SERVICE ALERT

Models Affected: All Mainship Models

TECHNICAL BULLETIN

DATE: August 15, 2006
BULLETIN NO. TB 0023
CONTACT: Jeff Schopperle

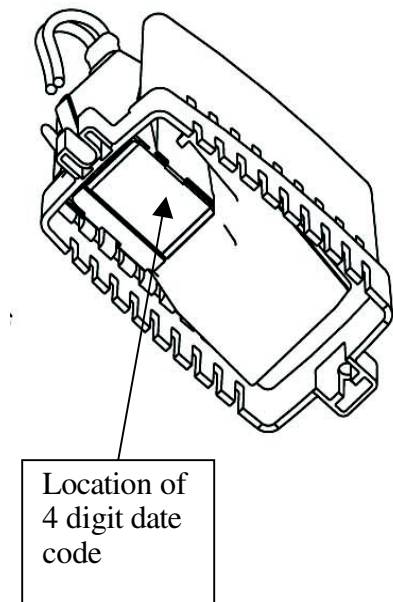
Due to a tolerance issue between the rubber grommet where the wires exit and the plastic housing a small percentage of switches may develop a crack that could potentially allow water to accumulate inside the switch causing it to fail. During our internal investigation we have discovered that product shipped between July 14th and August 4th 2006 may be subject to this failure. We are containing all products in-house and have temporarily shutdown production until the issue has been resolved.

In order to verify specific product, individual OEM boxes are stamped with the date the product was packaged. In addition a four digit manufacturing code is located on the base of the switch. Switches containing a four digit date code greater than or equal to "1956" must be contained. Please see below for location of date code.

We anticipate having a resolution in place and will be shipping product by September 8th, 2006.

However, we continue working to improve this date. As an alternative option, our standard mercury switches are available and can be shipped to customers during this transition. Mercury legislation prohibits us from shipping to California, Connecticut and Maine.
